# 2004 - 2009 Cadillac XLR and XLR-V: Service Bulletin: XLR Roof Does Not Latch At Rear Corners In Stowed Position

## #PIC4547A: XLR Roof Does Not Latch At Rear Corners In Stowed Position - keywords latch loose mid open potentiometer retract stow trunk - (Oct 23, 2008)

**Subject:** XLR Roof Does Not Latch At Rear Corners In Stowed Position  
**Models:** 2004 - 2009 Cadillac XLR and V-Series

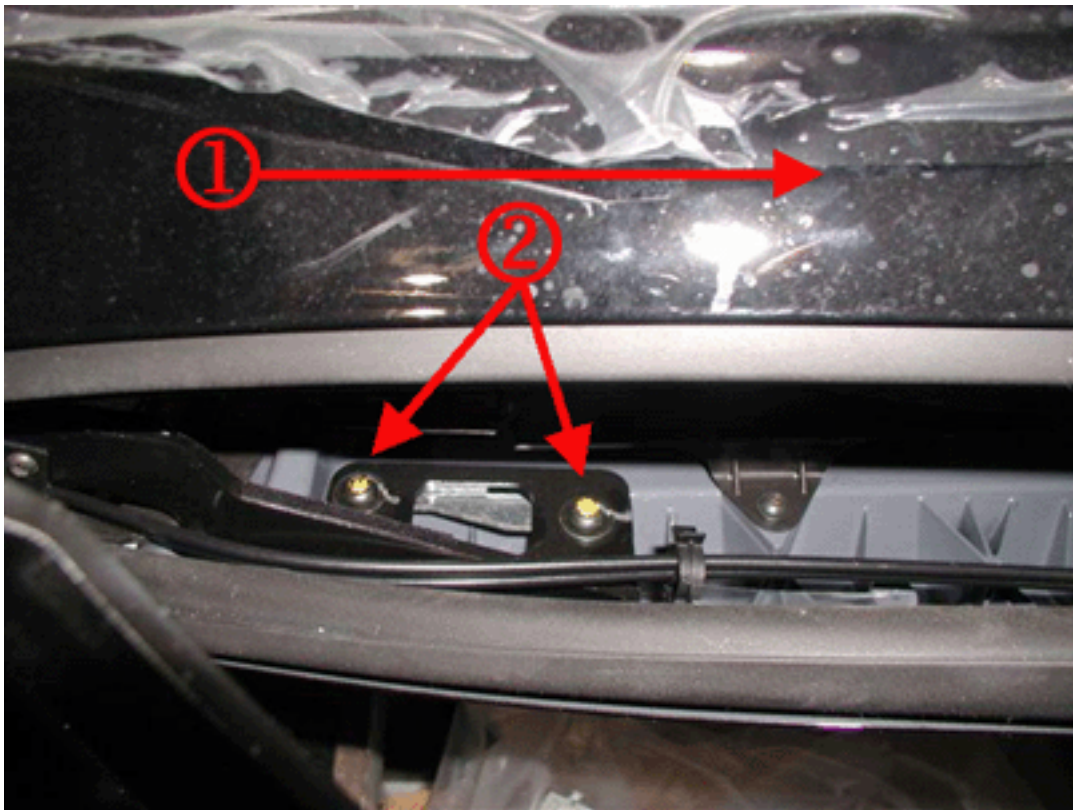
Some customers may comment of a mark in the paint on the roof panel. This mark may be on the drivers or passengers side of the roof and typically the size of a pencil eraser. Further inspection of the retractable roof may indicate when the roof is stowed, the rear corners of the roof are not secured in trunk area. This may be the result of a misadjusted roof panel.

1. Lower roof into trunk as far as it will go. Stop when trunk starts to close. Check to see if the rear roof latches engage the lower support.
2. Scribe the current position of the rear roof panel pivot bracket

bolts. These marks may be needed if the panel moves more than needed. The position should only change about .5 mm (one half mm).

3. Loosen both of the rear roof pivot brackets to rear roof panel fasteners one turn (both driver and passenger sides). These only need to be loose enough to allow the bracket to slide under the bolt shoulder. Do not allow the shims (if present) to become mis-positioned.
4. Manually lower the panel so the rear latches engage and latch. Lightly bump/thump the rear corners of the roof panel above the latches using your open palm.
5. Re-tighten the previously loosened fasteners to the specifications listed in S.I (Doc I.D. = 1739799)
6. Cycle the roof and ensure that it latches properly in both the up position and down position with out assistance. If it does not latch in the up position the strikers can be adjusted.

(1) Front Of Vehicle

## (2) Loosen One Turn
